City of Richmond
Urban Development Division

Report to Development Permit Panel

To: Development Permit Panel
From: Joe Erceg
Manager, Development Applications
Date: March 26, 2003
File: DP 02-218226
Re: **Application by Jema Properties Consulting Ltd. for a Development Permit at
7531 Moffatt Road**

Staff Report

PARKING PLAN
SCALE: 1/8" = 1'-0"

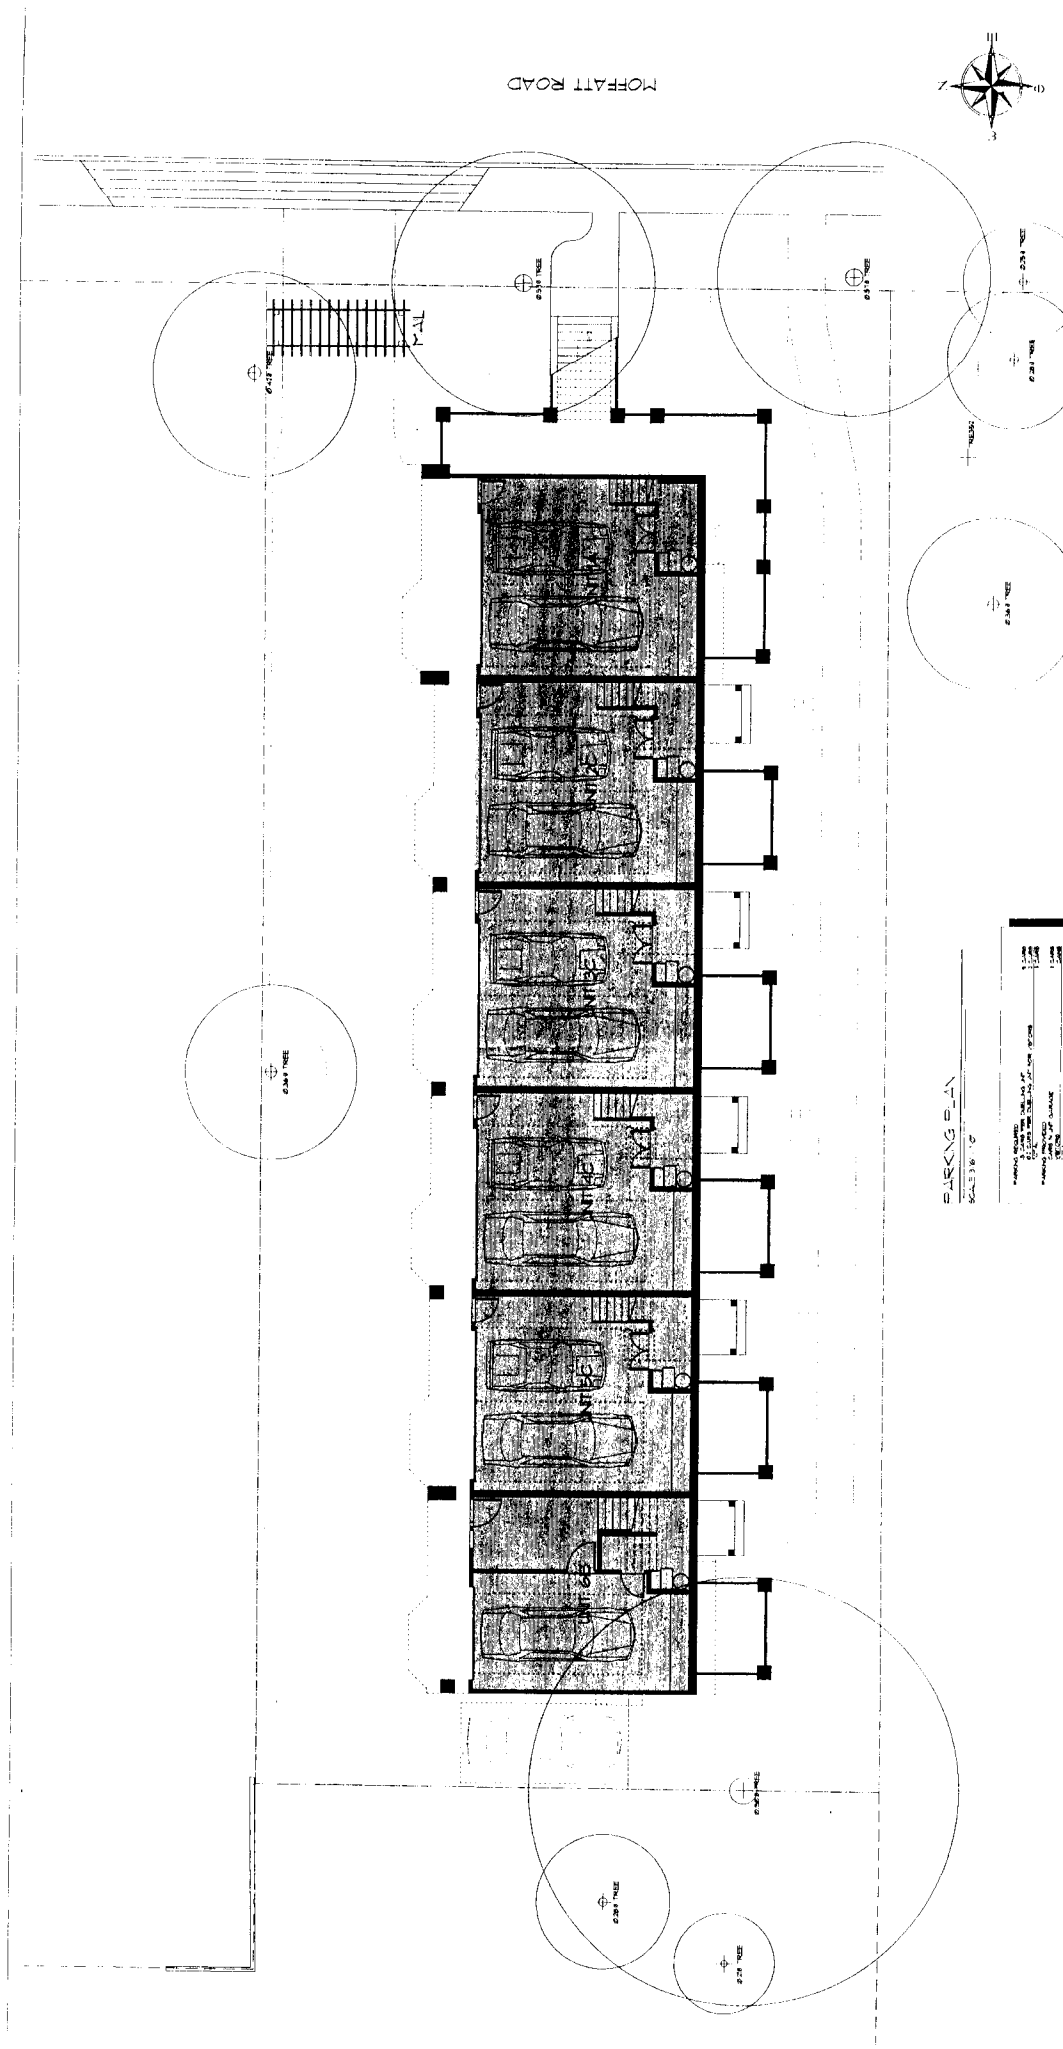
We note that you have one (1) visitor parking space, whereas the bylaw requires two (2). Even though this is a small project, we should point out that some Councillors have been opposing any reductions in visitor parking. I also note that your resident parking exceeds the bylaw requirement, but it is all in garages and not very useful for visitors.

See also comments made at RZ application. Throat width must be minimum 6 m clear pavement width to driveway letdown.

- The landscape plan and the development were good. The lane was considered tight and it was questioned how the fence would be protected. Light landscaping along the driveway was suggested. The pedestrian trellis could be moved forward and signage could be included. Additional ground cover could be located around the perennials.

- The project was appreciated. The colours and materials were good, as were the presentation and articulation. The roofline was a bit severe and “arc like” but would be well hidden by landscaping. A suggestion that valley’s at the third point of the ridge line be used. The handling of the corner unit was good. The width of the driveway was questioned. The fence should be protected with a hedge.

1. Reduce the number of visitor parking spaces from two (2) to one (1); and
2. Reduce the public road setback from 6 m (19.85 ft.) to 0.3 m (0.98 ft.) for a stair and entry trellis.

The project will require variances to visitor parking, which help to reduce the impact of automobiles. Staff have no objection, as these variances have been granted in the past.

LANDSCAPE PLAN

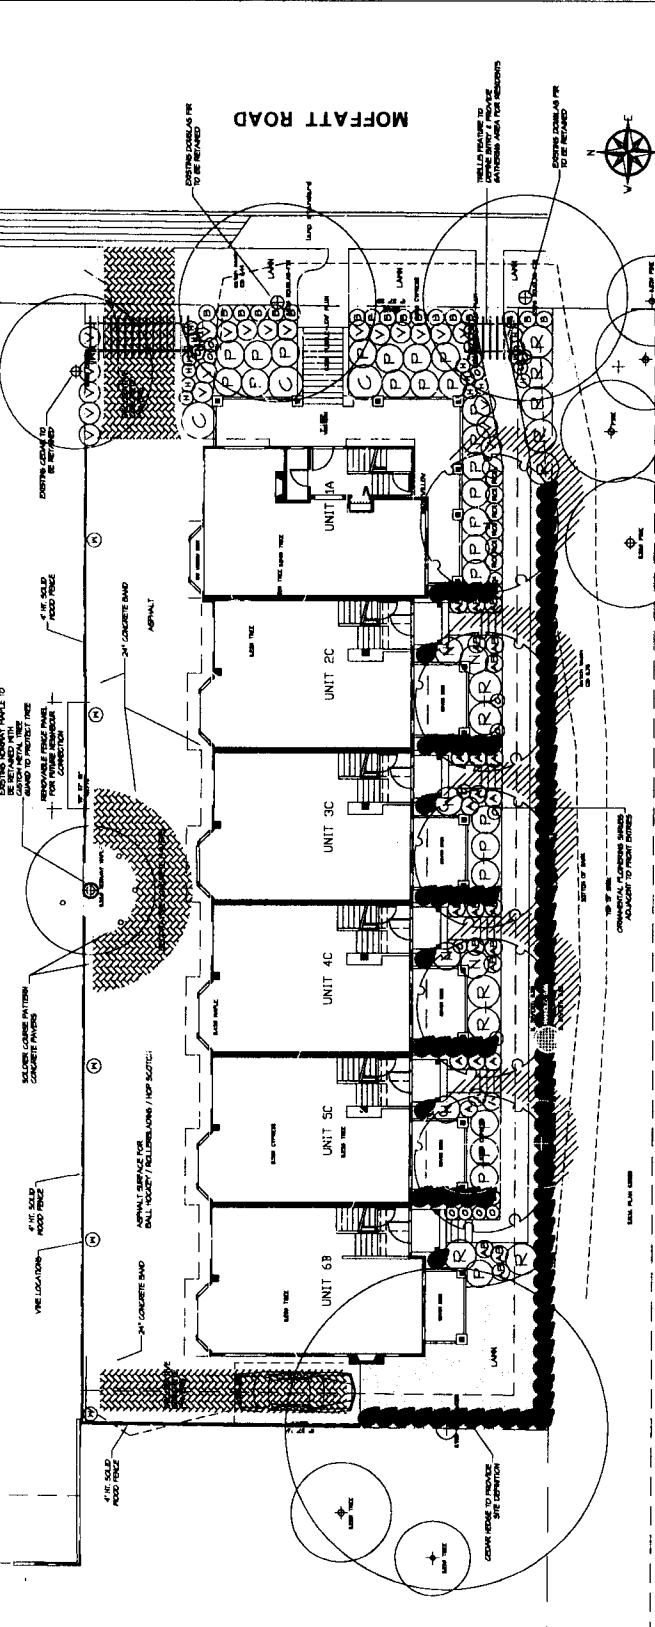
This infill project attempts to take into account the conditions on the adjacent properties and has retained all of the better existing trees on the site. We note that several mature trees are to be removed. Although these trees have some problems (co-dominant leaders, etc.), they still fall within our tree-replacement policy, and therefore we recommend that the landscape plans be amended to include a minimum of four (4) trees of 10 cm calliper. Before a Building Permit is issued, the existing trees to be retained should be fenced, and we require evidence that you have retained a professional to monitor the trees during construction.

- The plantings around the mail area should be kept low.
- The raised entry and the through units were appreciated and were considered to contribute to the liveability and future popularity of the units. The fence and tree should be protected from vehicle use. The removal of overgrown trees was supported. The colour and material choices were complimentary to the project. The front of the development had interest which was enhanced by the mature landscaping. A concern was expressed for the rear (garage) area and the suggestion was made that an opportunity existed to introduce variation to the lower level.

- The below deck area should be protected against use as storage. A hedge could replace the fence.

- that there was not enough room along the edge for a hedge;
- ivy could be planted against the fence;

- low plantings would be located around the mailbox;
- as there would be no recognition of the length of the building once the adjacent lots developed, a determination had been made to not increase the risk of roof penetration by incorporating valleys; and
- no hatch for storage would be located under the deck.

There are conditions to be met: Prior to forwarding this application to Council, a Letter of Credit will be required for landscaping, and prior to a Building Permit, the existing trees should be fenced, and there should be evidence of a contract with a professional who will monitor the existing trees during construction.

UNIT B

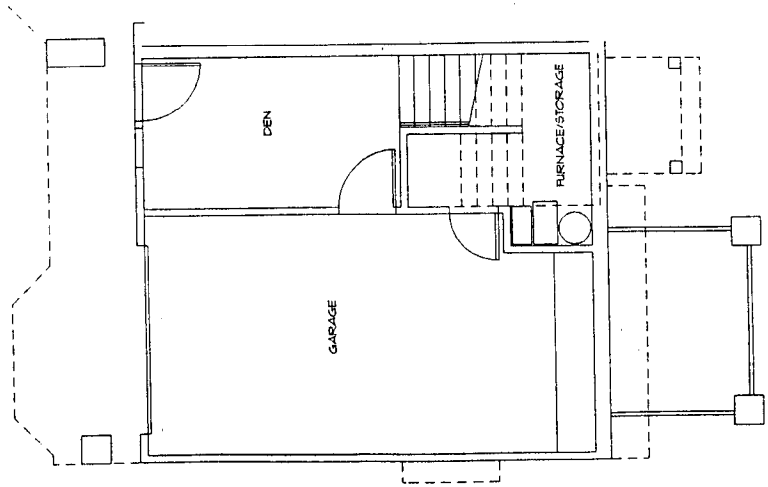
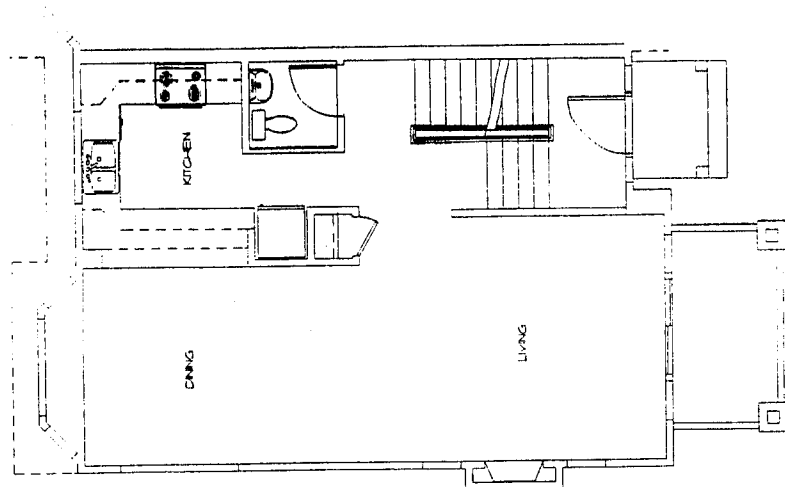
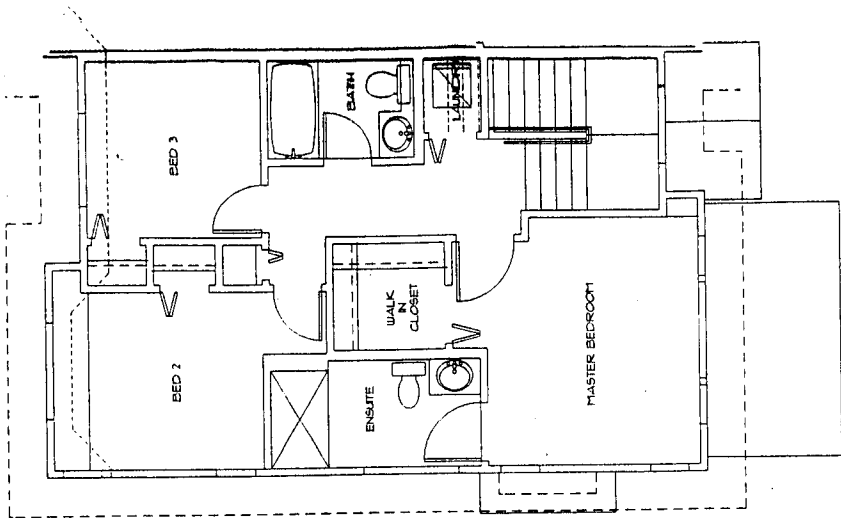
Detailed Building Code analysis required re: classification, fire separation, fire fighting provisions, exiting, etc. Show section of grading at the property lines---retaining wall and drainage? Separation of townhouse units to the building exterior. What are the variances if any being granted? Mail kiosk, fireplace in unit B?
